Technical Service Information

THM 3T40 (125C) GASKET CHANGE

Figure 1

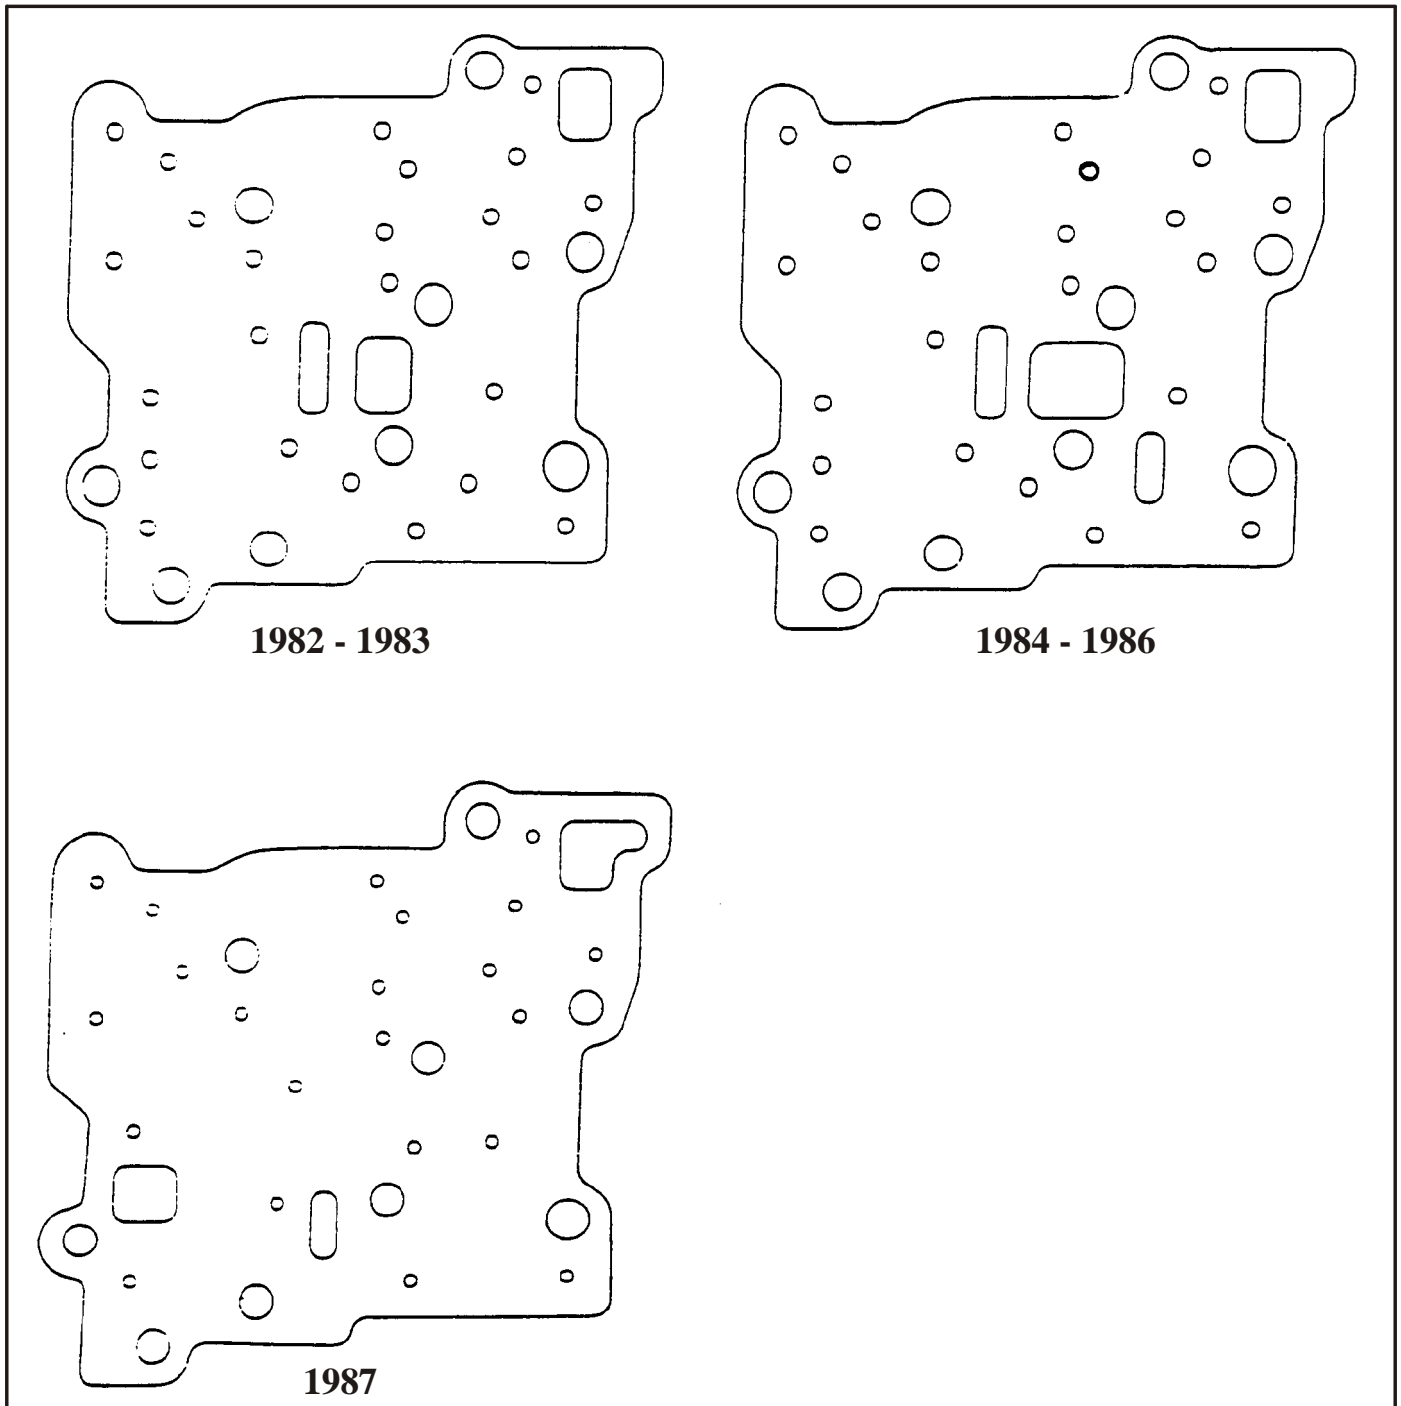
NOTE: GASKETS DO NOT RETROFIT, MIS-MATCH OF GASKETS CAN CAUSE NO TCC APPLY OR NO TCC RELEASE.
